UNITED STATES
 NUCLEAR REGULATORY COMMISSION
 REGION II
 101 MARIETTA ST., N.W., SUITE 3100
 ATLANTA, GEORGIA 30303

Inspection Report Nos. 50-325/80-12
 and 50-324/80-11

Report Nos. 50-325/80-12 and 50-324/80-11

Facility Name: Brunswick

ACTIVITY IN TERRESTRIAL VEGETATION
IN PCI/GM (WET)

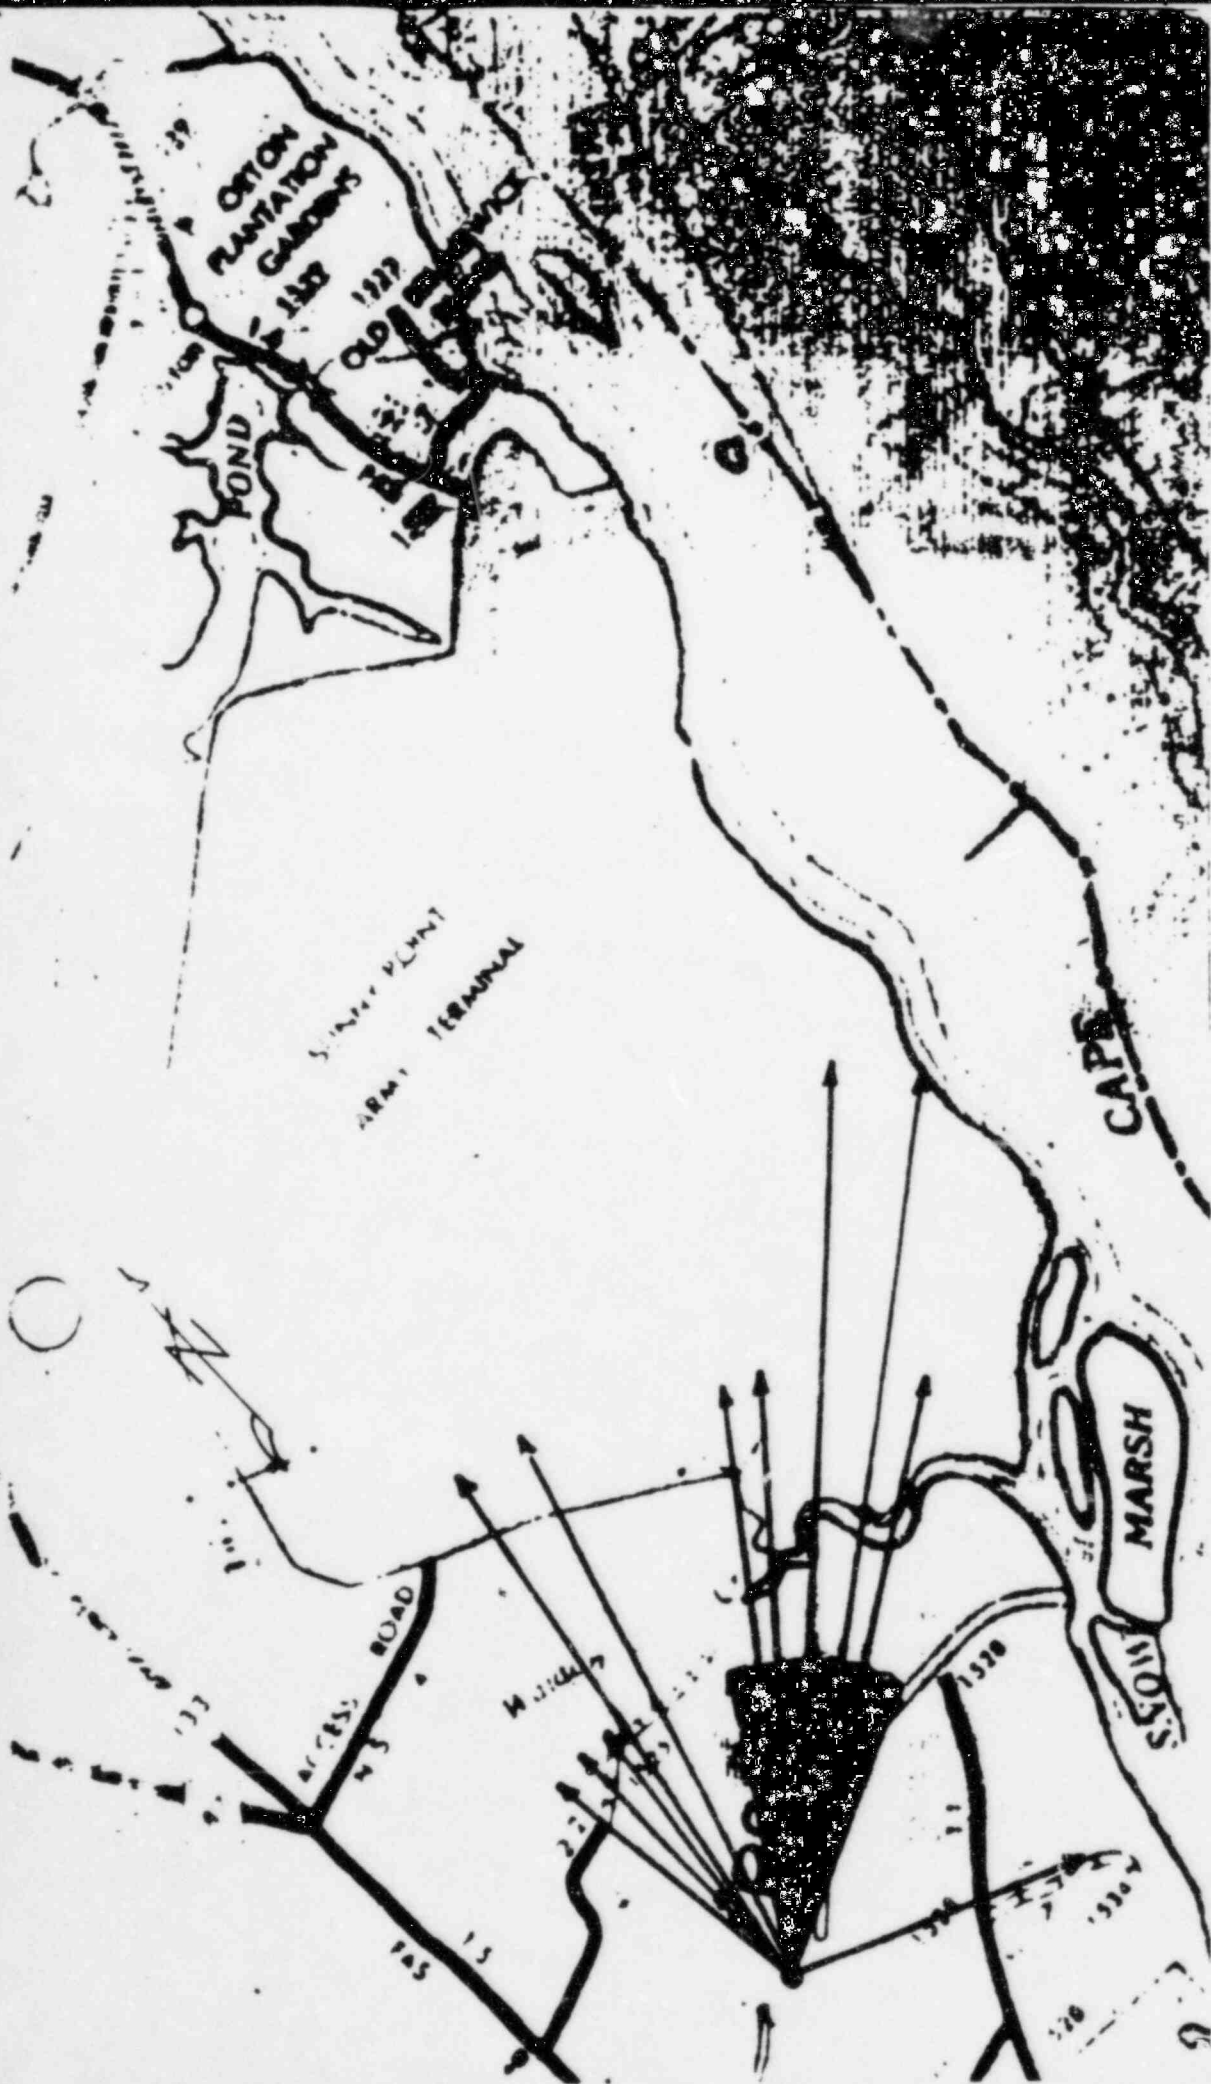
- b. Since the samples taken from February 22 to April 4 were only terrestrial vegetation, the inspector reviewed these levels against previous background samples. As shown in Table III.1 and Figure III.1, the levels of activity were elevated by a maximum factor of 164 onsite and 51 offsite (9 miles NE at Snow's Cut). However, the licensee acknowledged that the effects of rain and snow (noted in Figure III.1) would act to "wash off" the activity from the pine needles. Table III-2 shows the amount of precipitation, measured by the National Oceanic and Atmospheric Administration, at Wilmington, North Carolina. Currently, there are no studies or documentation available to determine the "retention factor" of pine needles.
